CONSTRUCTION SUMMARY

Lindsay 2017 Developments Inc. / Sugarwood

Lot/Unit: 3    Phase/Building: 1    Model/Floor Plan: White Lake (4204) Elev A 3Bed 2.5Bath

**B PARTIAL MAIN FLOOR**

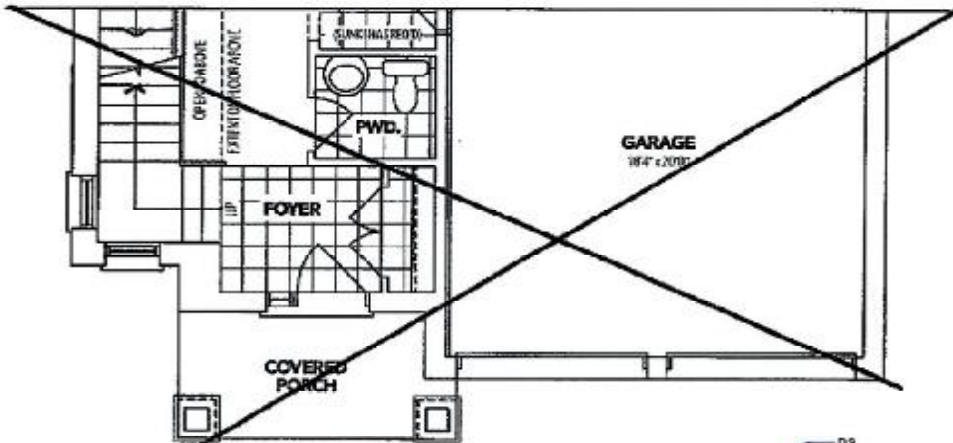
Inv.5766	1 - To supply and install the optional side door (GRADE PERMITTING).. see sketch #1 for details	
Line 73613	Note:	
29Aug22 / 1Sep22

**SKETCH #2**

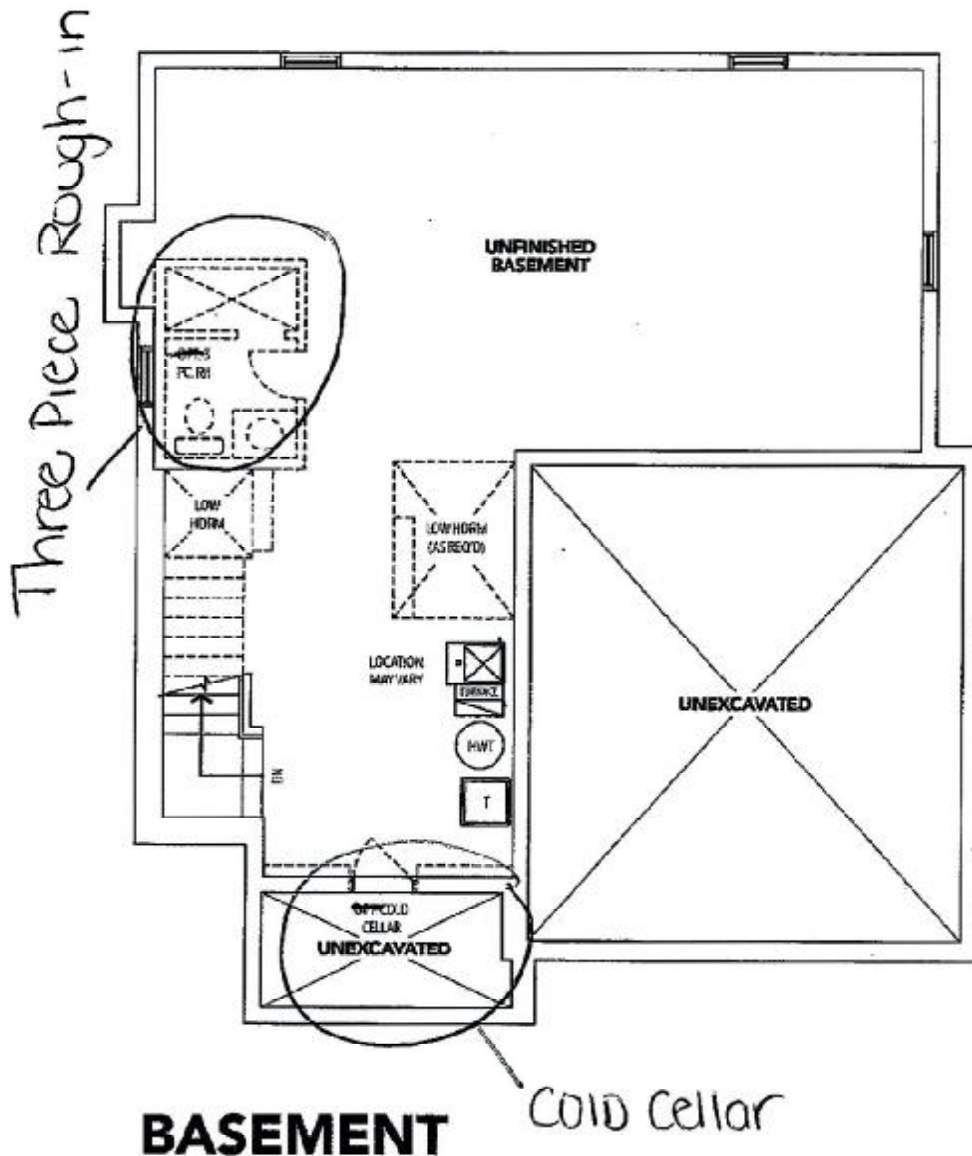
Inv.5766	1 - To supply and install the optional Cold Cellar.. see sketch #2 for details	
Line 73614	Note: THIS UPGRADE IS TO BE COMPLELTED BY THE CONCRETE AND DRAIN COMPANY	
29Aug22 / 1Sep22

Inv.5766	1 - To supply and install the Optional Three Piece Rough-in, in the Basement.. See sketch #2	
Line 73612	Note:	
29Aug22 / 1Sep22
